Application Ref: NP/23/0281/LBA

Proposal Alterations in association with changes to existing guest

house & residential dining (Class C1) with bespoke gin distillery (B2) & small bar/restaurant (Mixed Use C1/A3).

Site Location St Davids Distillery, Restaurant & Rooms, 11-13, Nun

Proposed Rear (West) Elevation 1:100

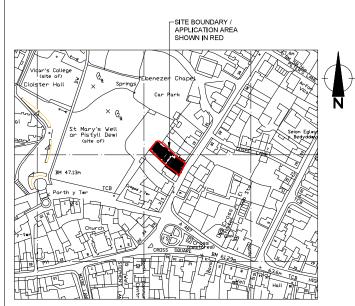
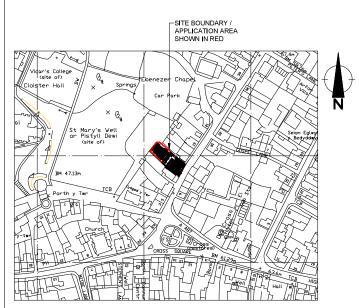
- Addition of steel kitchen flue to rear elevation exiting at first floor level (painted black).
- Internal alterations to lower ground floor (addition of partitions to create protected lobbies to the staircases).

Erw. The proposed metal flue introduces an incongruous feature, a stark contrast to the Victorian proportions and style of the property, as well as the traditional style and construction of the abutting conservatory.

- 2. The proposed development would have an unacceptable impact on the setting adjacent listed buildings in terms of the proposed metal flue when viewed from the north. As such, the proposal is contrary to the provisions of Section 66 of the 1990 Act.

Proposed Ground Floor Plan 1:50

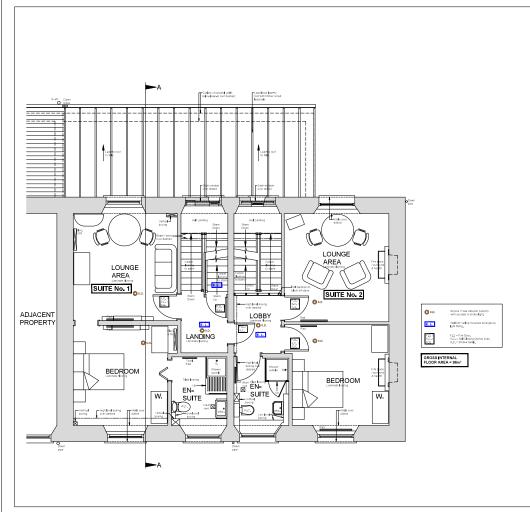
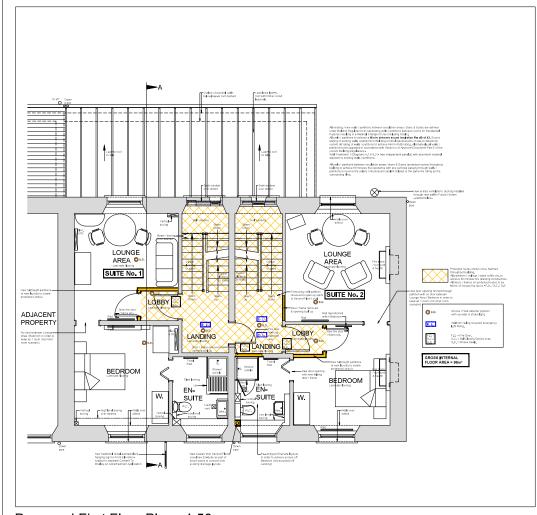
- Internal alterations at ground floor level to create protected lobbies to rear kitchen (existing office) and to rear bar. Both lobbies are placed within the rear rooms fitted with fire doors, the bar lobby providing a further fire door into the proposed (front) distillery room (reducing the existing modern opening). Partitioning to right-hand front room to create a disabled upvc, closing-up the existing door off the hallway. Insertion of fire door between two right-hand rooms.

Proposed First Floor Plan 1:50

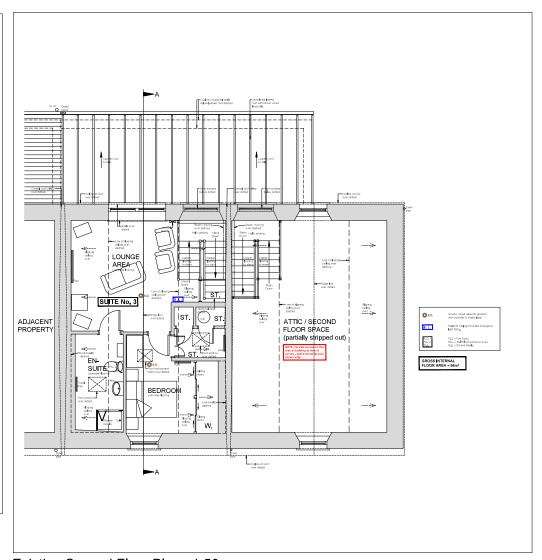
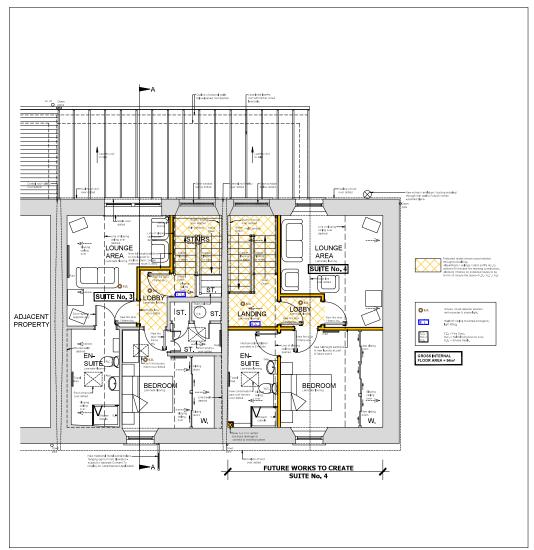
- Internal alterations at first floor level to create two protected lobbies and blocking of two existing doorways.
- Internal alterations to (modernized) second floor including new partitions to create a suite of guest rooms.
